**Site Plan Review Committee (SPRC)**  
**Staff Report for**  
**1600 S Eads – Crystal Towers 3**

**Crystal Towers 3 (SP #)**  
**1600 S. Eads**  
(RPC#s)

**SUMMARY:** The applicant, Dweck Properties, proposes to construct a new residential and a new retail building at the Crystal Towers Apartment complex, located at 1600 S. Eads Street. Existing Crystal Tower building 1 and 2 will remain.

**Figure 7: Proposed Site Circulation**  
**GROUND LEVEL**

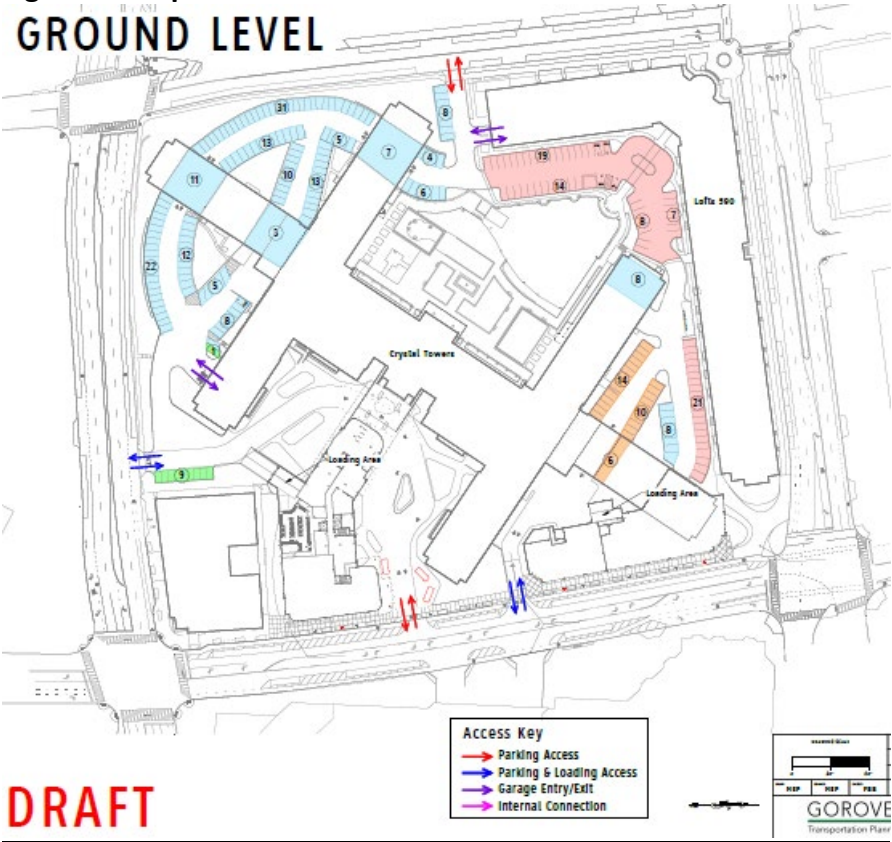
The proposed retail building will tie into an existing residential building at the ground floor level and will extend out to front along S. Eads Street. In the proposed plan, there will be two curb cuts on S. Eads Street (See Figure 7 below). The curb cut most adjacent to the proposed residential building would provide internal site access and could exit on 18<sup>th</sup> Street. The curb cut adjacent to the retail building provides access to limited parking and the loading area for retail.

Figure 8: Building Height's Map – Crystal City Sector Plan

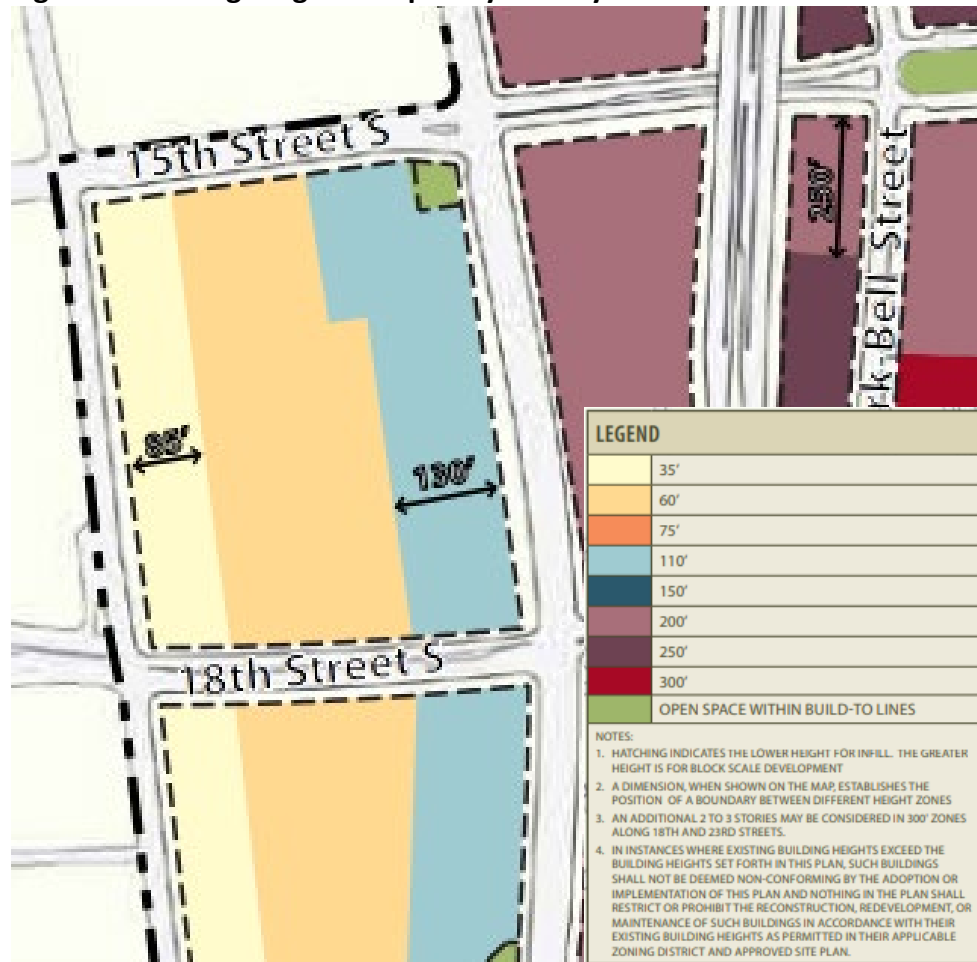
**Building Height:** The applicant is proposing a building height of approximately 132' for the residential building. The underlying zoning district of RA4.8 allows for a building height of 136' from average site elevation to the top of the building penthouse. The Crystal City Sector Plan provides guidance for a 110' building height on this site, tapering down to 60' and then eventually 35' (see figure 8). The Sector Plan's guidance is codified in the C-O-Crystal City zoning district, however, the applicant is not requesting a rezoning, so is not subject to the C-O-Crystal City building height. Staff continues to analyze this deviation from the Sector Plan to determine if it is acceptable at this location.

**Figure 9: Crystal City Sector Plan Design Buildable Envelope and Massing Strategies**

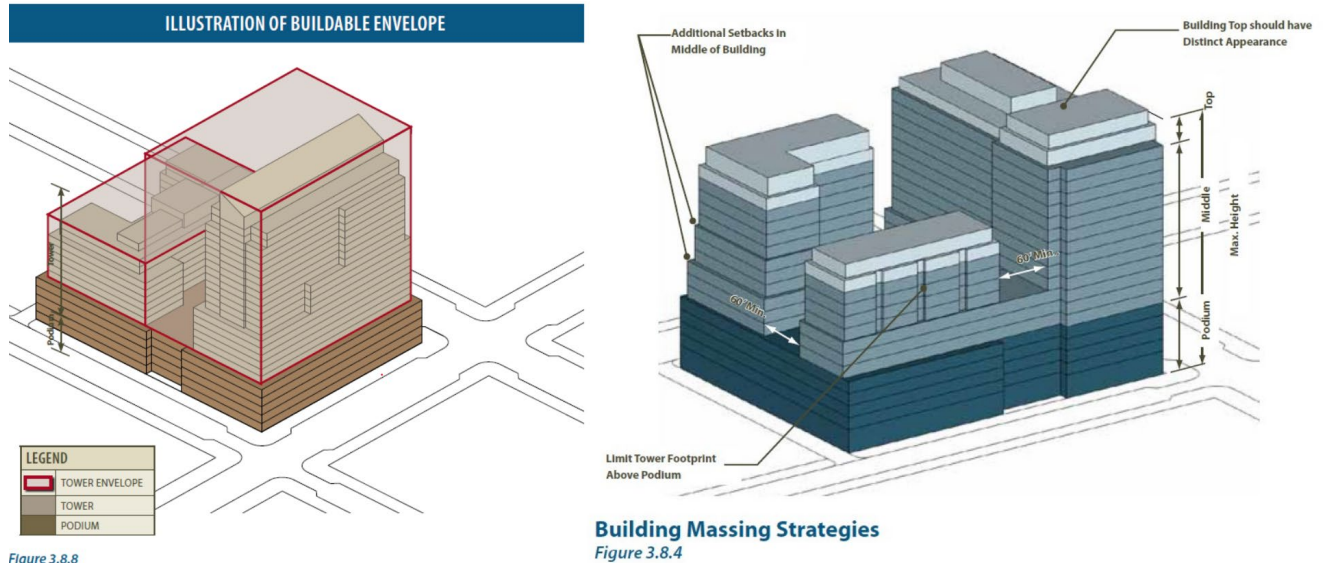
- **Maximum Allowable Height:** As noted above, the combined height of the podium and tower for development of the subject site should not exceed 110 feet and should taper down to 60' internal to the block and then 35' along S. Fern Street. As discussed above, the proposed residential building is not consistent this guidance.

- o **Podium Height:** The Sector Plan recommends that the maximum height of any podium (first five to six floors of the building) should not exceed 65 feet. The proposed buildings meet this guidance, however, the proposed residential building has a podium of four floors instead of the anticipated five to six floors and the proposed retail building is a single story building.

o Podium Separation Requirement: The Sector Plan recommends that where a podium base does not occupy an entire site and no party-wall condition exists, the podium should maintain a minimum separation distance of 40 feet from all other adjacent buildings, except when the separation is for an alley or other vehicular way, which should typically be 25 feet wide. The proposed residential building does not meet this requirement. There is a 30-foot separation between the proposed building and the existing Crystal Flats building.

o Top of the Podium: The Sector Plan recommends that the top of the podiums have a horizontal architectural unity through the use of cornices or other banding projections placed at the top of the upper most floor of the podium. The proposed residential building does not have an architectural treatment that distinguishes the top of the podium.

- o Building Setback Profiles: The Sector Plan recommends two (2) approaches for achieving sculpted buildings with distinct podiums, towers, and tops – a Multiple Setback Approach, and a Single Setback Approach. While the podium should continuously engage the Build-to Line and meet the back of the sidewalk, the tower massing above should taper or step back from the podium along streets and open spaces to achieve aesthetically interesting and attractive buildings, and to allow for light and air between buildings. For building tops, it is generally recommended that the upper two (2) to four (4) floors of all buildings should be no closer than 20 feet from the Build-to Line, unless the proposed design of the building top involves a dramatically creative architectural treatment that is integral to the overall composition of the building. The step-back approach for the proposed residential building and staff will continue to evaluate whether these deviations detract from the overall Sector Plan objectives.
